From: Chavez, Carl J, EMNRD
Sent: Thursday, October 06, 2011 7:14 AM
To: Chavez, Carl J, EMNRD
Subject: Navajo Refining Company (UICI-008) WDWs 1, 2 & 3 MIT Meeting Determination on October 5, 2011

Subject: Holly-Frontier (Navajo Refining Co.) OCD UIC Class I (NH) Injection Wells (UICI-008) & Significant Variation in Annulus Pressures Noticed from Monitoring
Location: Telephone Conference Call
Start: Wed 10/5/2011 10:30 AM
End: Wed 10/5/2011 12:00 PM
Recurrence: (none)
Meeting Status: Meeting organizer
Organizer: Chavez, Carl J, EMNRD
Required Attendees: Bailey, Jami, EMNRD; Sanchez, Daniel J., EMNRD; Ezeanyim, Richard, EMNRD; Jones, William V., EMNRD; Dade, Randy, EMNRD; VonGonten, Glenn, EMNRD; Griswold, Jim, EMNRD; Lackey, Johnny; Moore, Darrell; Gonzales, Elidio L, EMNRD; Brown, Maxey G, EMNRD
Categories: Red Category

Purpose: To discuss monitored variation in injection well annulus pressures during injection for 3 UIC Class I (NH) Injection Wells in Eddy County.

WDW-1 Inspection & MIT (8/14/2009)

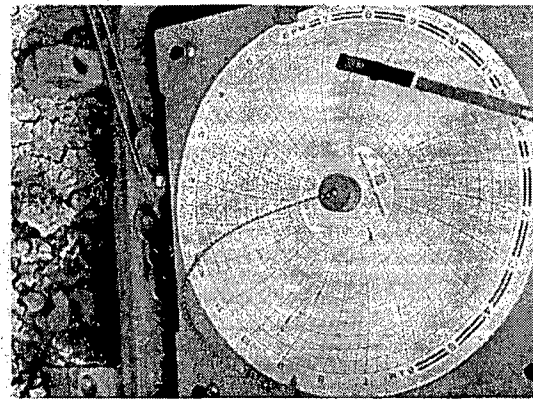
Recommended AFE to replace 1/2 inch dia. pipe with 1 inch or greater.

Drums of ethylene glycol stored on ground need to be on impermeable pad

- 1) Passed standard annulus pressure MIT (Start @ 575 psig & End @ 580 psig) over 30 minutes.
- 2) AFE submitted to replace ½ inch dia. piping w/ 1 inch or greater- safety and breakage concerns.
- 3) Operator indicated WAMs fluid level ok (no loss or addition of ethylene glycol).
- 4) Drums containing chemicals need to be stored in impermeable pad area or removed from facility.

WDW-2 Inspection & MIT (8/14/2009)

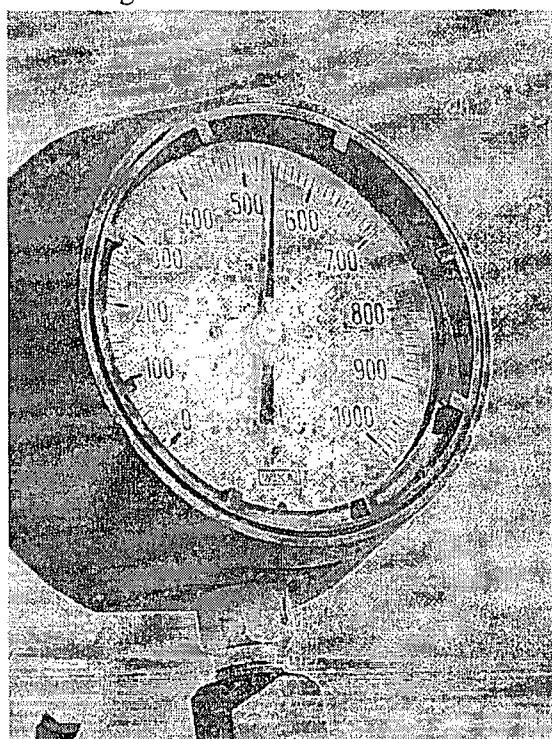
Ethylene glycol fluid needs to be stored on impermeable pad area

Connection to annulus through small 1/2 inch dia. fitting

Chart recorder set-up w/ valve arrangement. Operator wants to replace ½ inch line with 1 inch or greater diameter size due to pressure on small line and breakage concerns during MITs.

WDW-3 Inspection & MIT (8/14/2009)

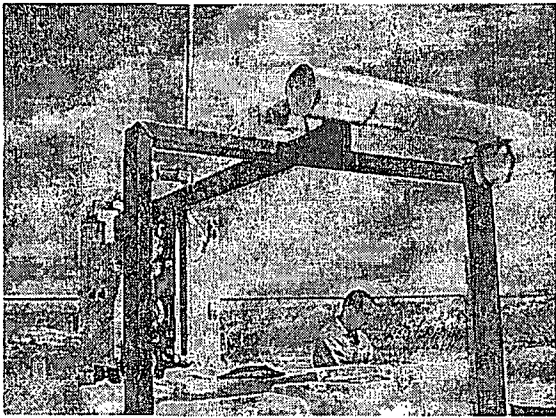
Rusty fittings near wellhead pinhole leak(s)?

Operator wants to replace $\frac{1}{2}$ inch nipple w/ at least 1 inch over breakage concerns and high pressure on small diameter pipe during the MITs, etc.

- 1) MIT passed (Start @ 560 psig w/
End @ 540 psig) on 8/14/2009.
- 2) MIT system integrity concerns about
WAMs Unit & ethylene glycol
leakage somewhere in the system.
No discernable stains, leaks have
been observed at surface. Company
called "300 PSI" performed (~ 2006)
a proprietary sealant leak application
from surface to 1000 ft. and from ~
7000 ft. to near top of perforated
interval.
- 3) Need to test all surface lines, valves,
etc. for pinhole leakage and proceed
into well if leak not found in surface
piping.
- 4) Drums need to be stored in the
impermeable pad area.
